PROJECT NAME Northern Bank Town Common Peer Review

Peer Review Comment Form

Northern Bank Proposal FBC Review

Comment #9: Building C primary massing exceeds maximum width

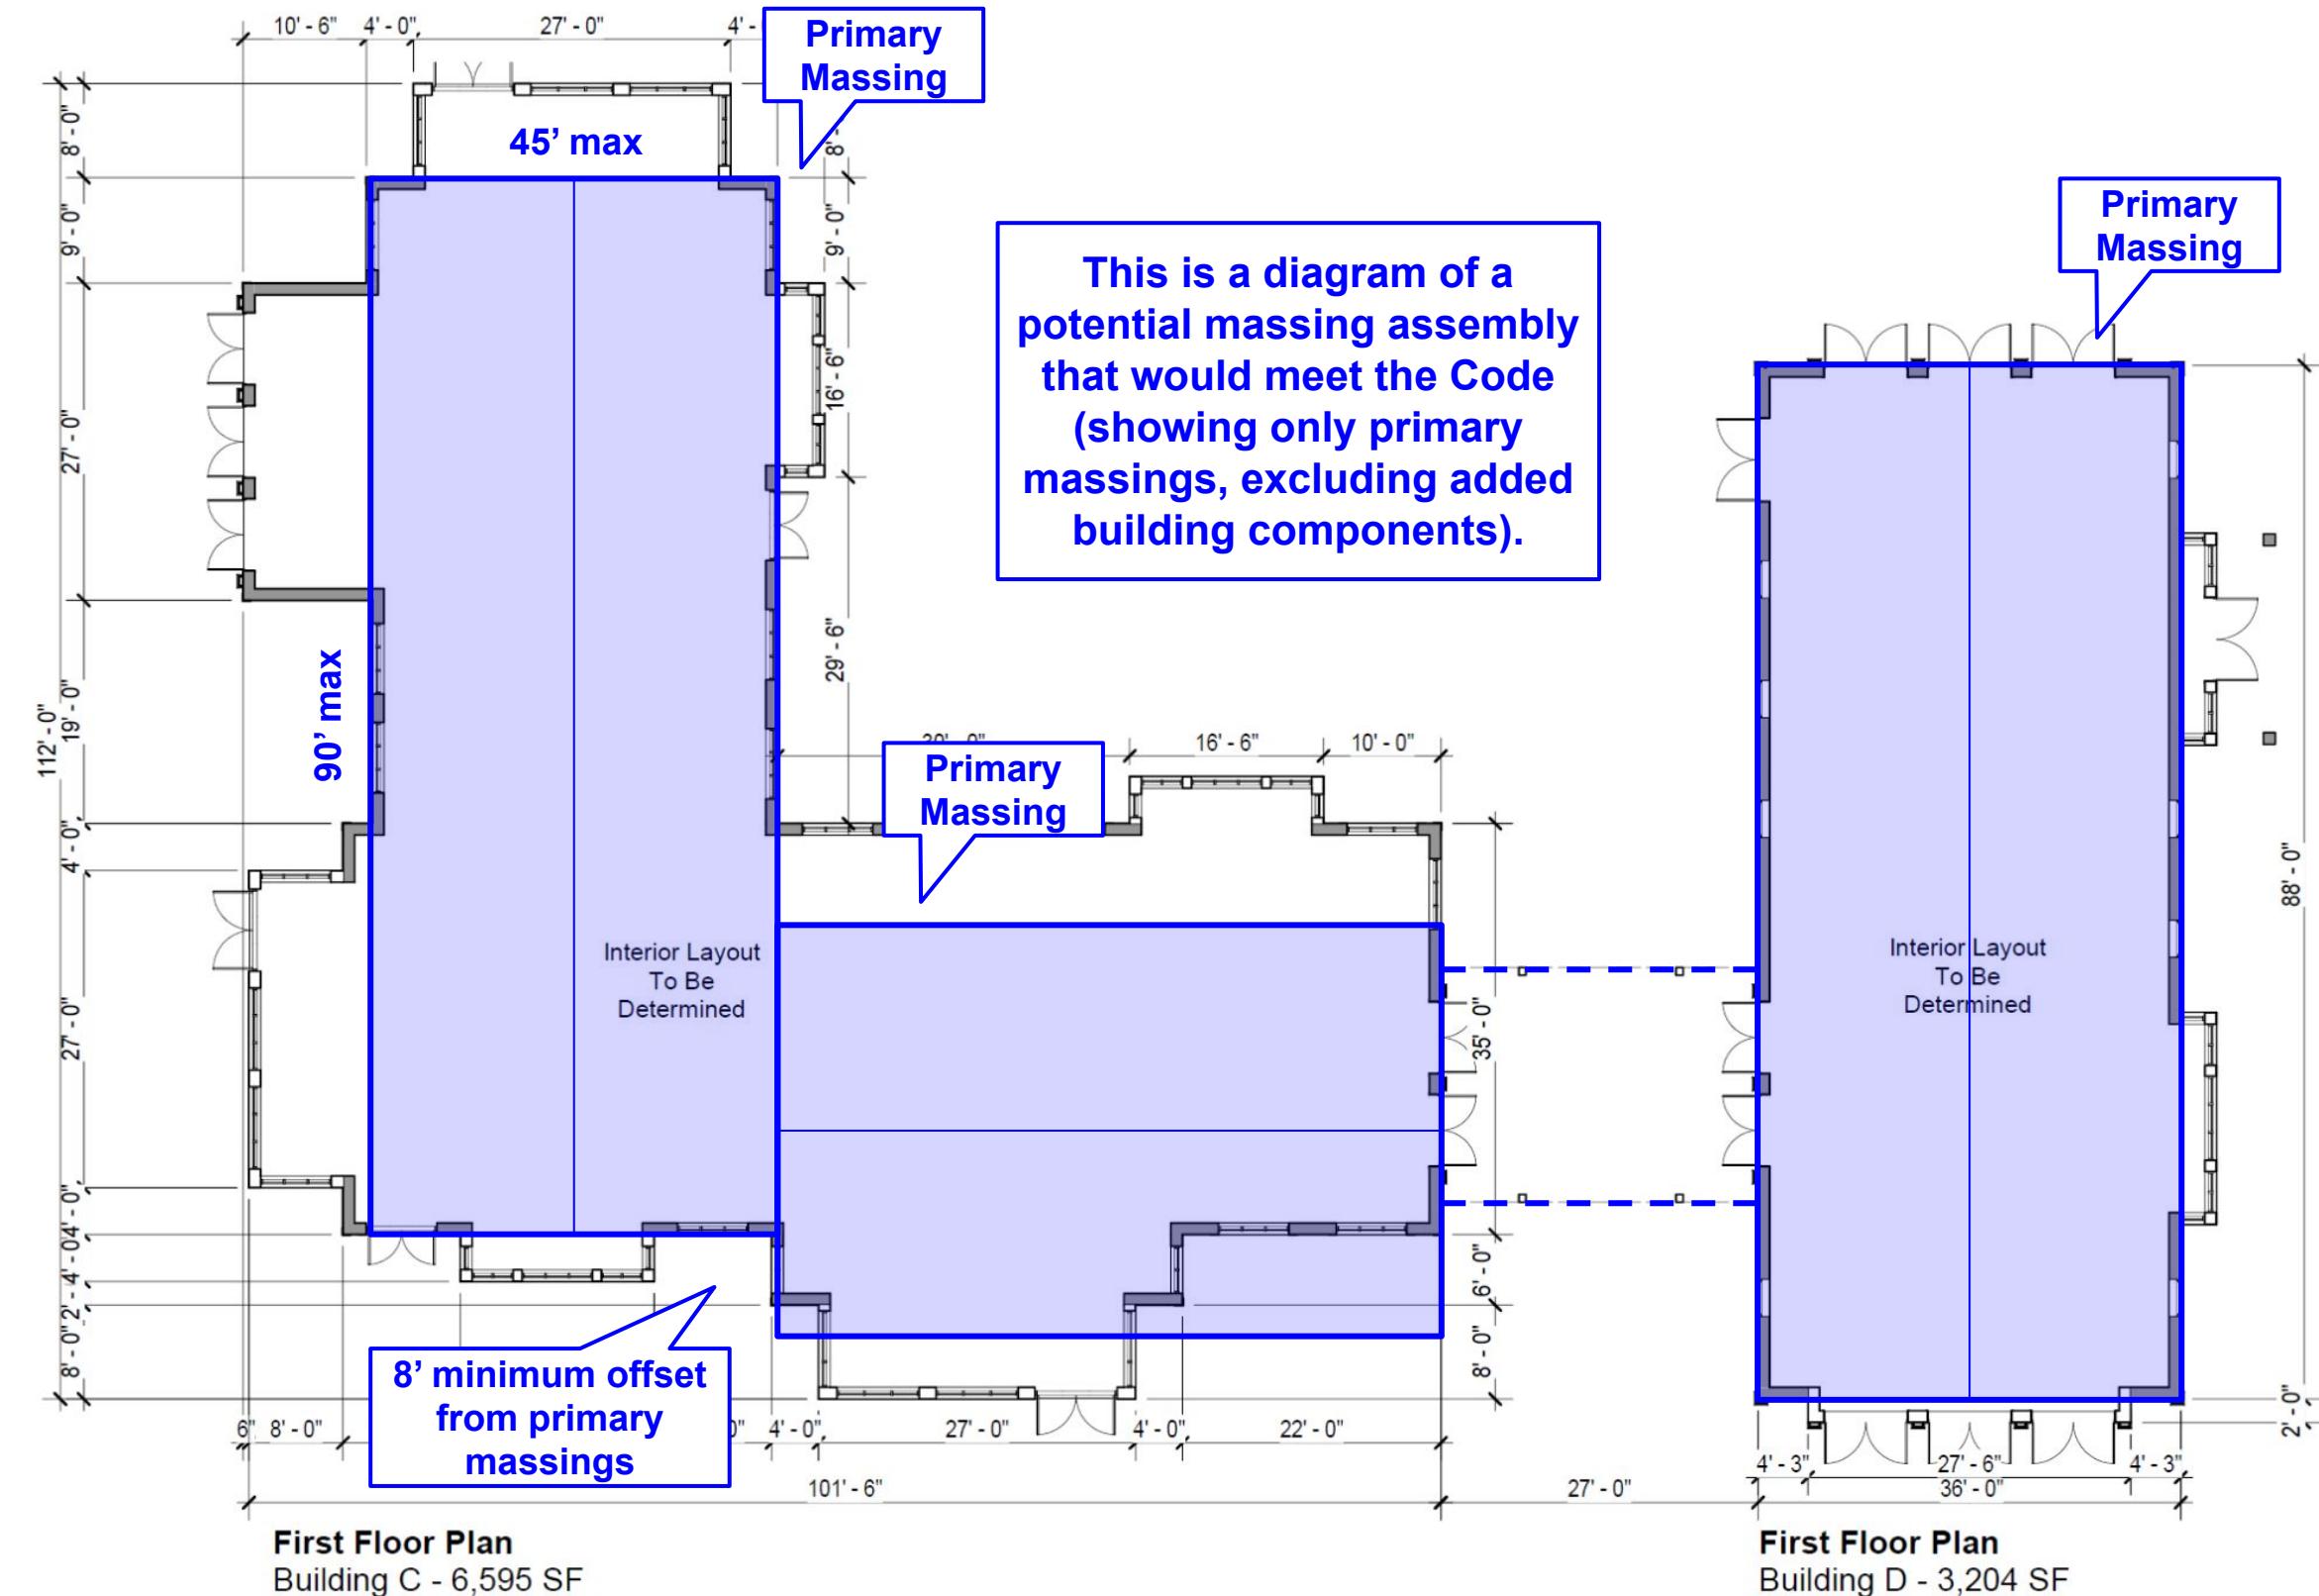
Comment #9	
Sheet No.	Building C & D - Floor Plan (Page 11 of "N Bank Architectural Updated 11-14-2022.PDF")
FBC Section	Building Standards §173-221.K.
FBC Text	The FBC table for Building Standards indicates that the maximum width of a primary massing with its long side oriented toward the front lot line is 65 ft.
Utile Comment	The width of the primary massing shown is 93'-6", exceeding the maximum of 65 ft. The maximum widths of primary massings with its long side oriented front is intended to reduce the perceived scale of buildings from the public realm.
Utile Recommendation	Utile recommends splitting this single primary massing into 2 primary massings that are offset from each other by the minimum required 8 ft, or alternatively, making the long, deep part of the building a primary massing and the side as another intersecting primary massing, etc.
